ADDENDUM NUMBER 2

SMITH PARK PAVILION
RETAINING WALL REPAIRS
Site #708, Bldg. #1470
5462 North 33rd Street
Milwaukee, WI 53209

Project Number: P603-15661

Date of Addendum: 9/15/16

NORTH WALL RESTORATION (REPAIR QUANTITIES)

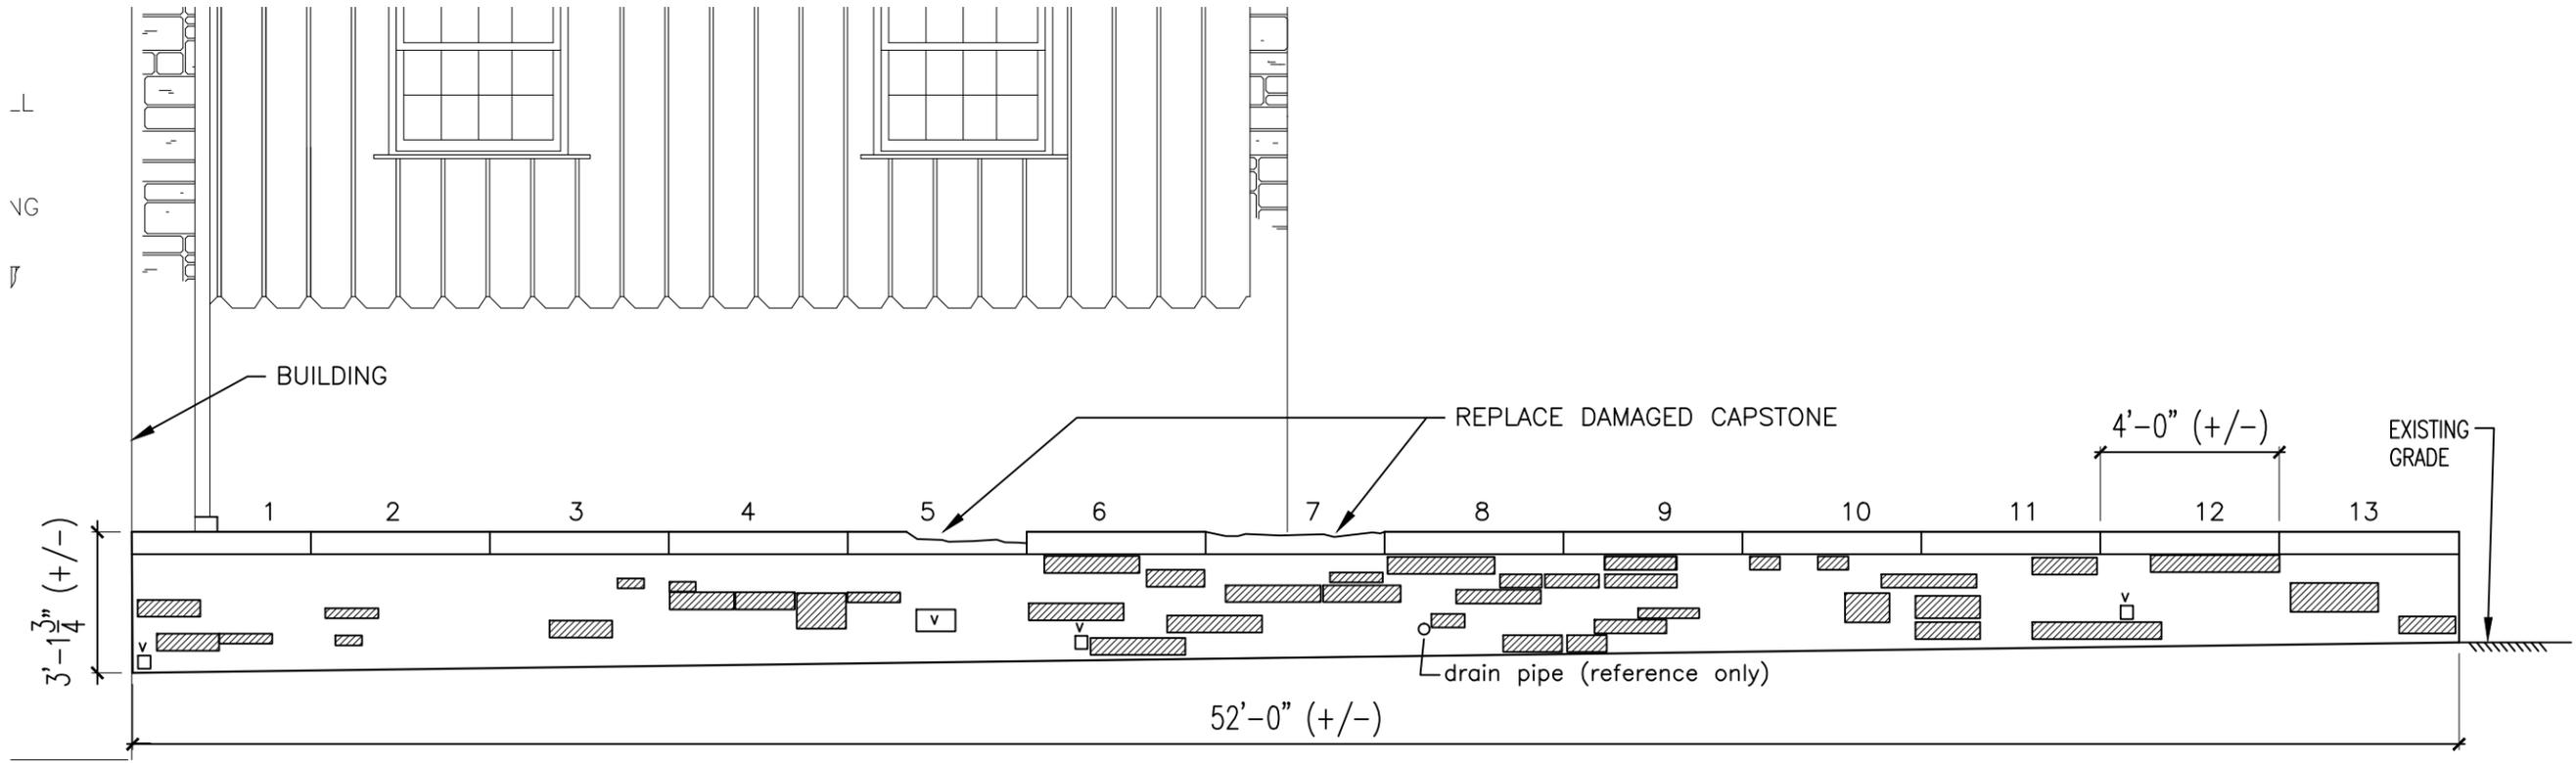
- 35.00 SF PARTIAL DEPTH REPAIR
- 20 LF EPOXY RESIN INJECTING

SOUTH WALL RESTORATION (REPAIR QUANTITIES)

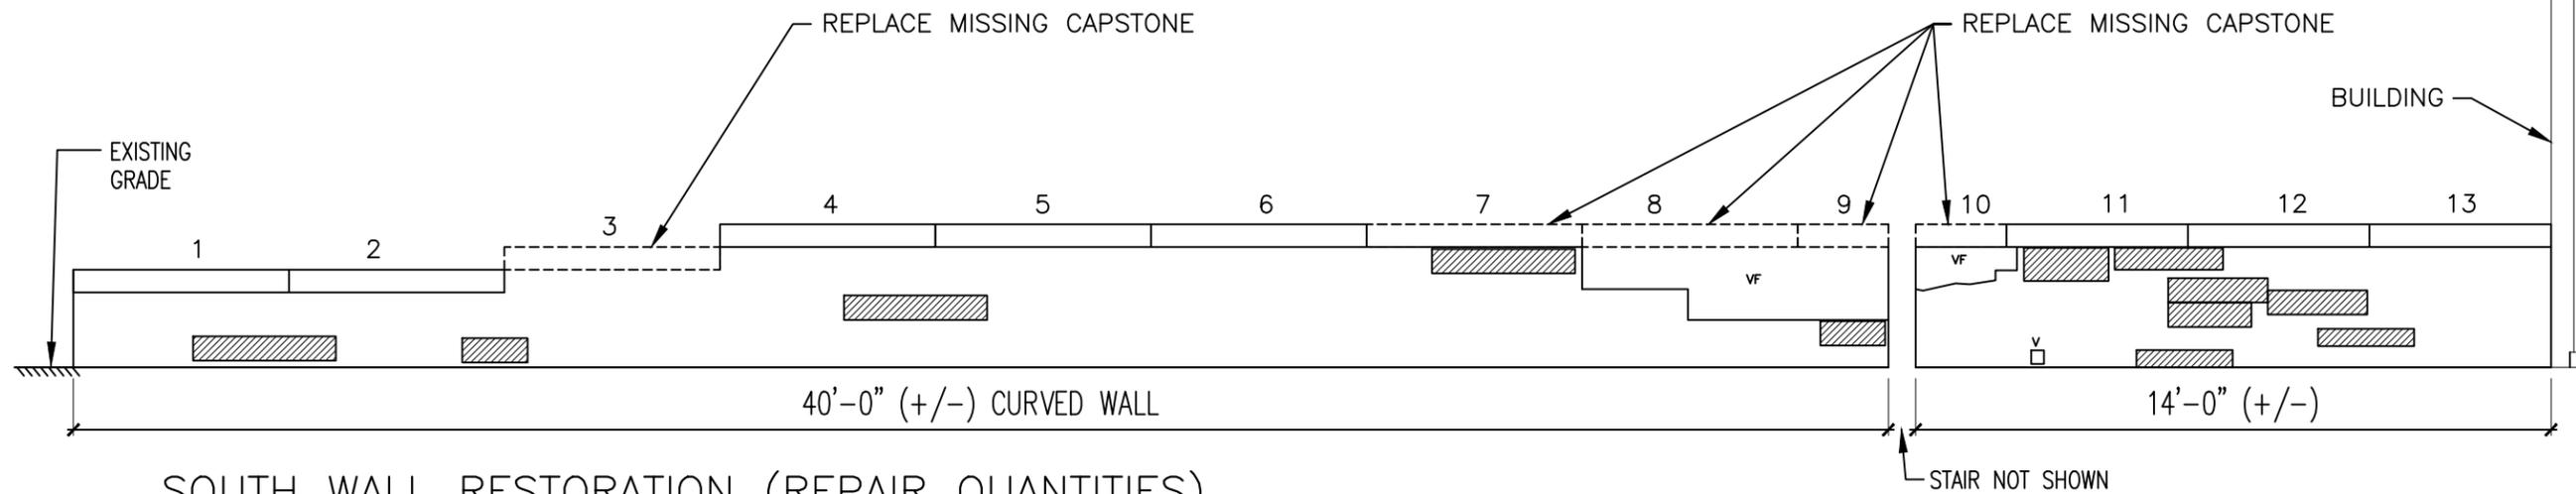
40.00 SF PARTIAL DEPTH REPAIR

16.00 SF FULL DEPTH REPAIR

30 LF EPOXY RESIN INJECTING

SOUTH PORTION OF SOUTH STAIR WALL RESTORATION

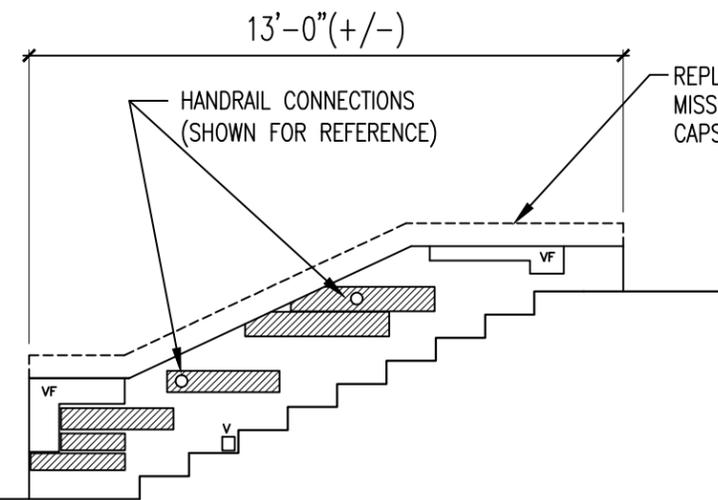
REPLACE MISSING STAIR RAILING WITH NEW GALVANIZED METAL PIPE RAILING, APPROX. 10'-0" (+/-) LONG, MATCH EXISTING
